CITY OF ALBUQUERQUE

RE: **Master Tech Auto**
304 Candelaria NW
Grading Plan Stamp Date: 1/15/20
Hydrology File: G14D093

Based on the submittal received on 1/21/20, this project cannot be approved until the following corrections are made:

GRADING AND DRAINAGE PLAN

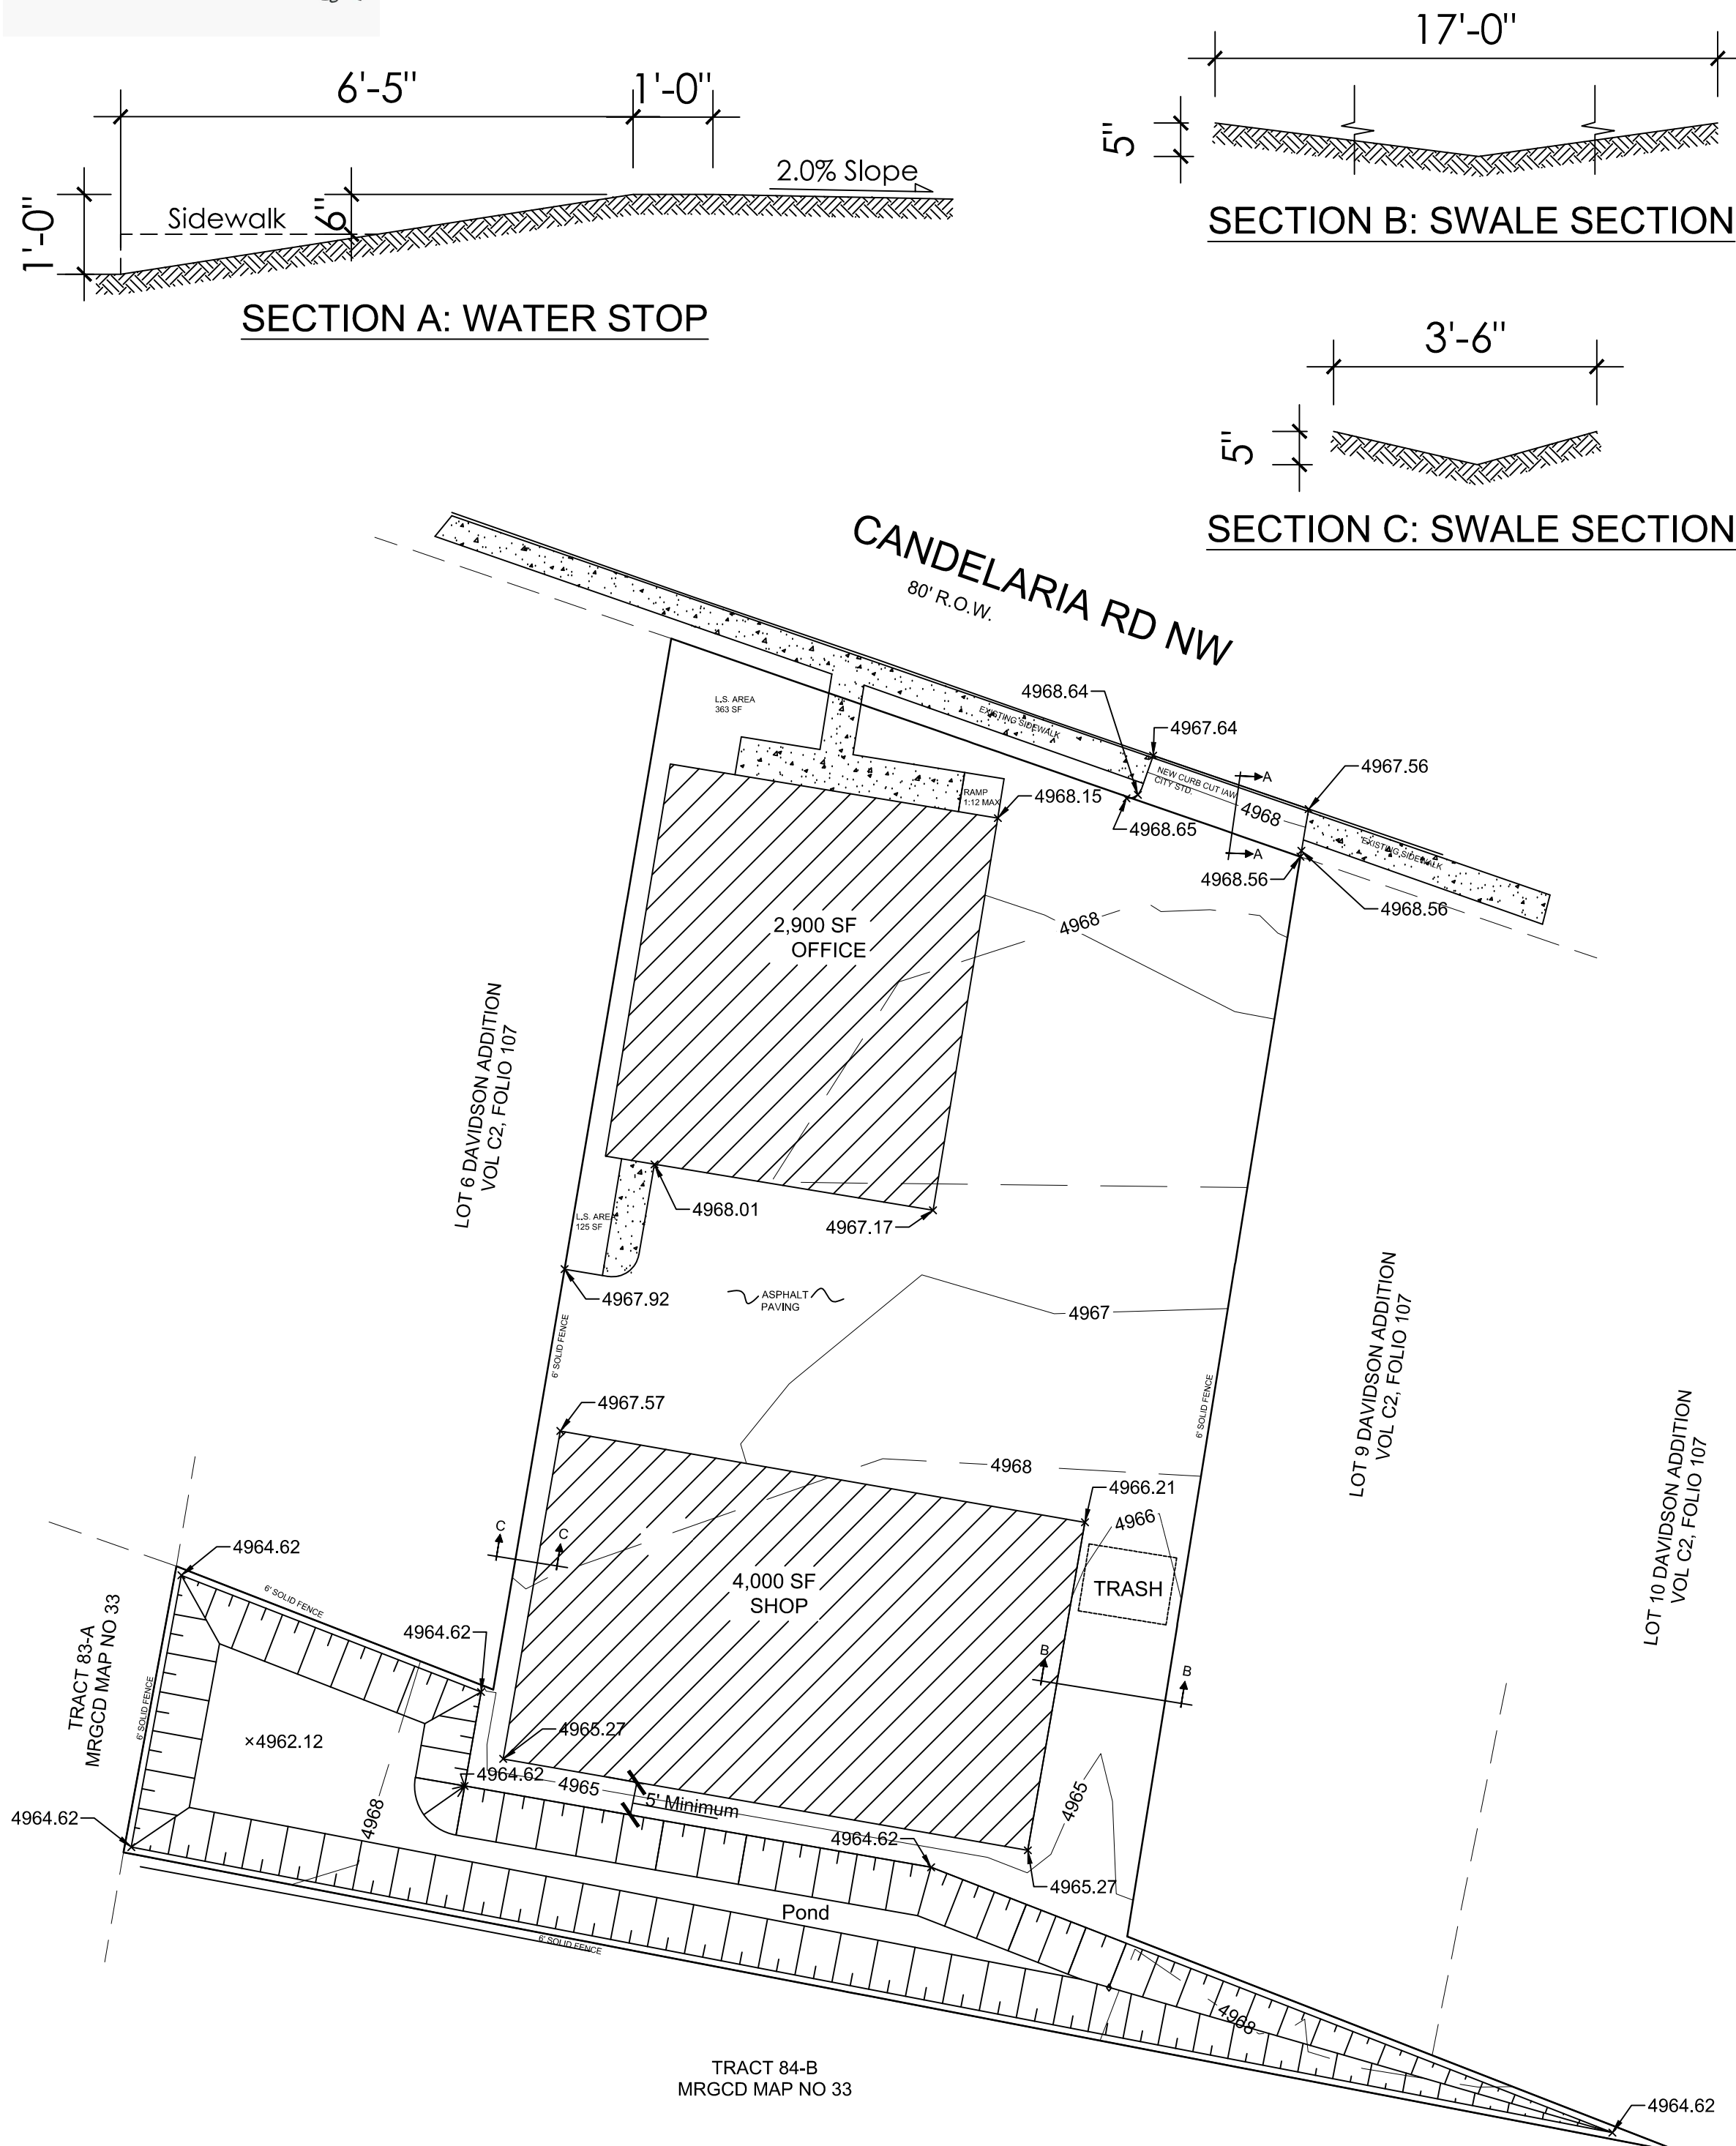
1. Remove the “Drainage Certification” language. This will be required later at Certificate of Occupancy.
2. The drawing needs to be scaled to a common Engineer’s Scale, such as 1:20; include a scale bar.

3. Include project datum; all existing survey, proposed grades, and benchmarks must be provided in NAVD 88.
4. In sections B-B and C-C, include the property line, existing and proposed walls, and grade changes, and channel lining. In accordance with DPM Ch.22, section 5 part B, grading and wall construction near the property line may not endanger adjacent property or constrain its use.

5. Provide hydraulic calculations for the section C-C and B-B swales, to ensure they can pass the 100 flows to the rear-yard pond without endangering the neighboring properties. Please divert the water around the dumpster pad as well.

6. Please label the pond with the stormwater quality volume and elevation, the 100-year volume and elevation, the pond crest elevation, add finished floor elevations to both buildings and ensure freeboard.
